Well Name: JRU APACHE FEDERAL COM	Well Location: T22S / R30E / SEC 13 / NESE / 32.391932 / -103.828584	County or Parish/State: EDDY / NM
Well Number: 701H	Type of Well: OIL WELL	Allottee or Tribe Name:
Lease Number: NMNM89051	Unit or CA Name:	Unit or CA Number:
US Well Number:	Operator: XTO PERMIAN OPERATING LLC

Notice of Intent

Sundry ID: 2834093

**Procedure Description:** XTO Permian Operating, LLC. respectfully requests approval to make the following changes to the approved APD. Changes to include SHL, KOP, FTP, LTP, BHL, casing design, cement program, mud circulation system and proposed total depth. FROM: TO: SHL: 2577' FSL & 927' FEL OF SECTION 13-T22S-R30E 2577' FSL & 967' FEL OF SECTION 13-T22S-R30E KOP: 2577' FSL & 927' FEL OF SECTION 13-T22S-R30E 330' FNL & 330' FEL OF SECTION 13-T22S-R30E FTP: 330' FNL & 330' FEL OF SECTION 13-T22S-R30E 330' FNL & 330' FEL OF SECTION 13-T22S-R30E LTP: 330' FNL & 100' FWL OF SECTION 14-T22S-R30E 330' FNL & 100' FWL OF SECTION 14-T22S-R30E BHL: 330' FNL & 50' FWL OF SECTION 14-T22S-R30E 330' FNL & 50' FWL OF SECTION 14-T22S-R30E The proposed total depth is changing from 20903' MD/9710' TVD to 20447.44' MD/9753' TVD XTO Permian Operating,

(20") x 13-3/8" x 9-5/8" x 5-1/2" MBU-3T-CFL-R-DBLO-SF Wellhead  
With 13-5/8" 10M x 7-1/16" 15M CTH-DBLHPS-SB Tubing Head  
And Drilling & Skid Configurations

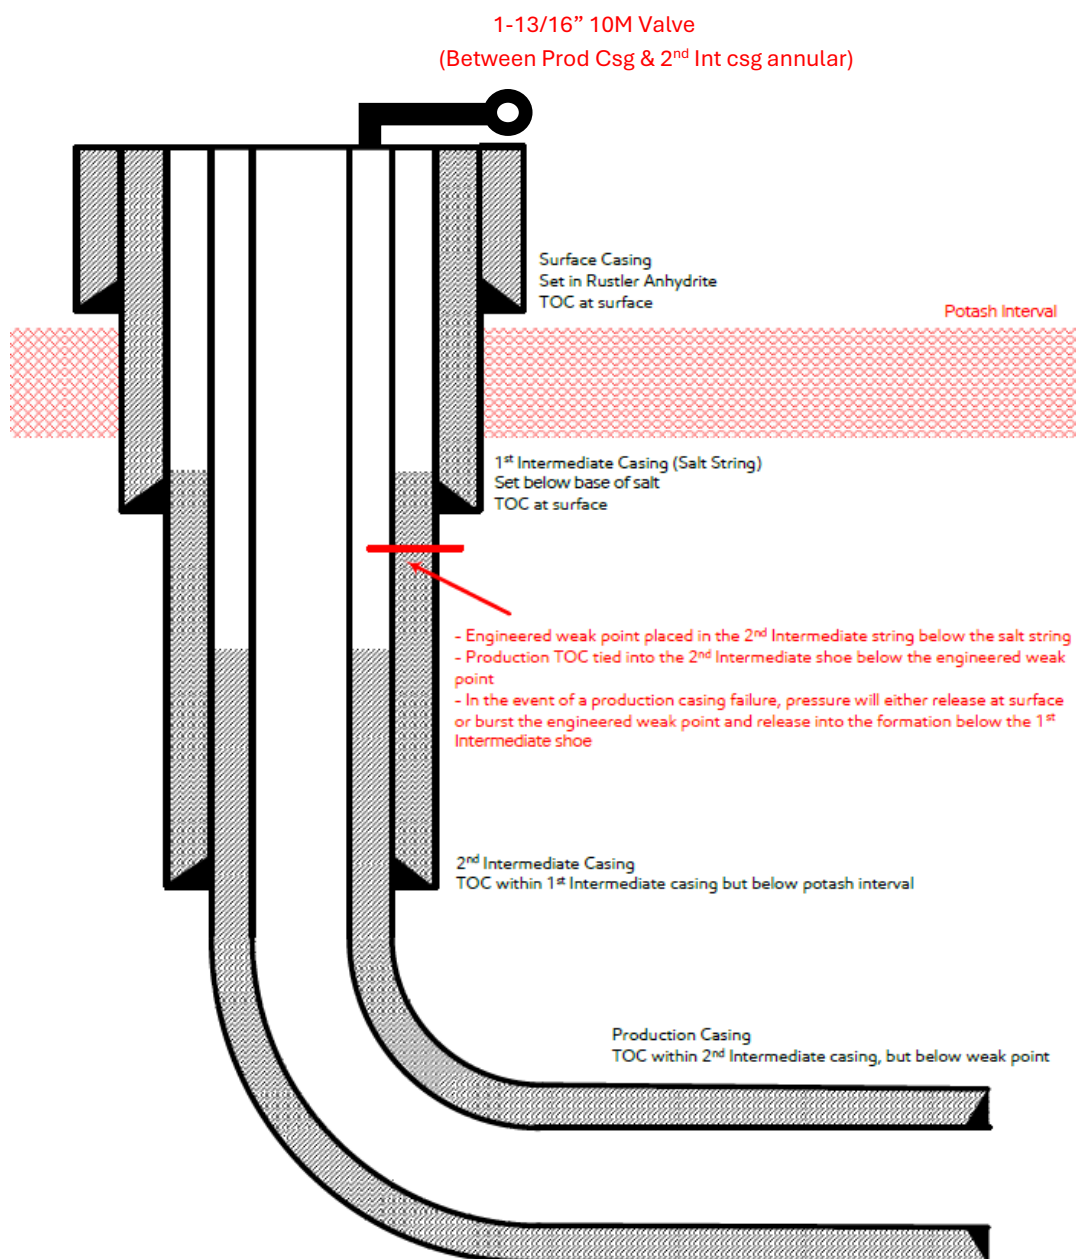
XTO Permian Operating, LLC. respectfully requests permission for a primary and a contingency drilling program for this well. Primary will be a 4-string design with an engineered weak point (R-111-Q: Figure F) & the contingency will be a 3-string design with an open production casing annulus (R-111-Q: Figure B).

- 1) Alignment with KPLA requirements per schematic below, with engineering weak point casing design and utilizing new casing that meets API standards.
- 2) Contingency plans in place to divert fluids away from salt interval in event of production casing failure.
- 3) Intermediate 2 casing will consist of a primary cement job with TOC at the top of the Brushy Canyon formation within the Delaware Mountain Group.
  - a. Bradenhead squeeze to be completed after primary cement job to tie back TOC to intermediate 1 “Salt string” & below Marker Bed 126 “Potash Interval”.
- 4) Production cement to be tied back no less than 500’ inside previous casing shoe (intermediate 2 casing) and below the engineered weak point.

**Figure B – 3 String Design – Open Production Casing Annulus (Updated May 2024):**

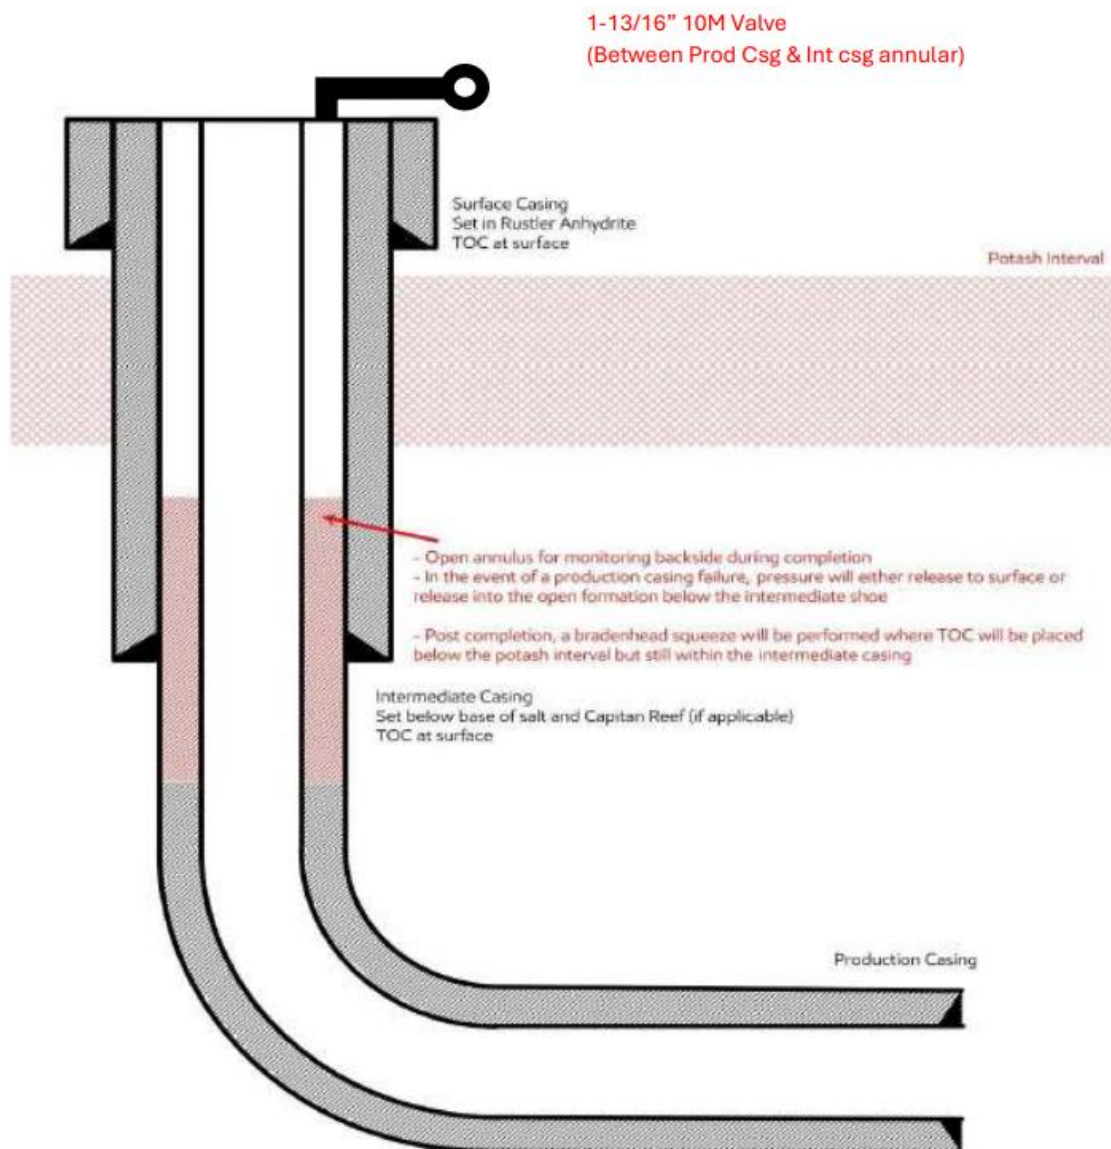
1. Alignment with KPLA requirements per schematic above, leaving open annulus for pressure monitoring during frac and utilizing new casing that meets API standards
2. Contingency plans in place to divert formation fluids away from salt interval in event of production casing failure
3. TOC in the annulus between intermediate & production casing string shall stand uncemented at least 500 feet below the intermediate casing shoe
4. Bradenhead squeeze to be completed within 180 days after hydraulic frac operations have been concluded to ensure at least a 500 feet tie-back has been established inside salt string but with top below MB 126

- ❖ **A monitored open annulus will be incorporated during completion by leaving the Intermediate Casing x Production Casing annulus un-cemented and monitored inside the Intermediate String.** Operator must follow monitoring requirements listed within R-111-Q. Tieback requirements shall be met within **180 days**.

**OPEATOR IS APPROVED TO USE A 3 STRING DESIGN CASING PLAN. ALL R-111Q REQUIRIEMENTS ARE APPLY.**
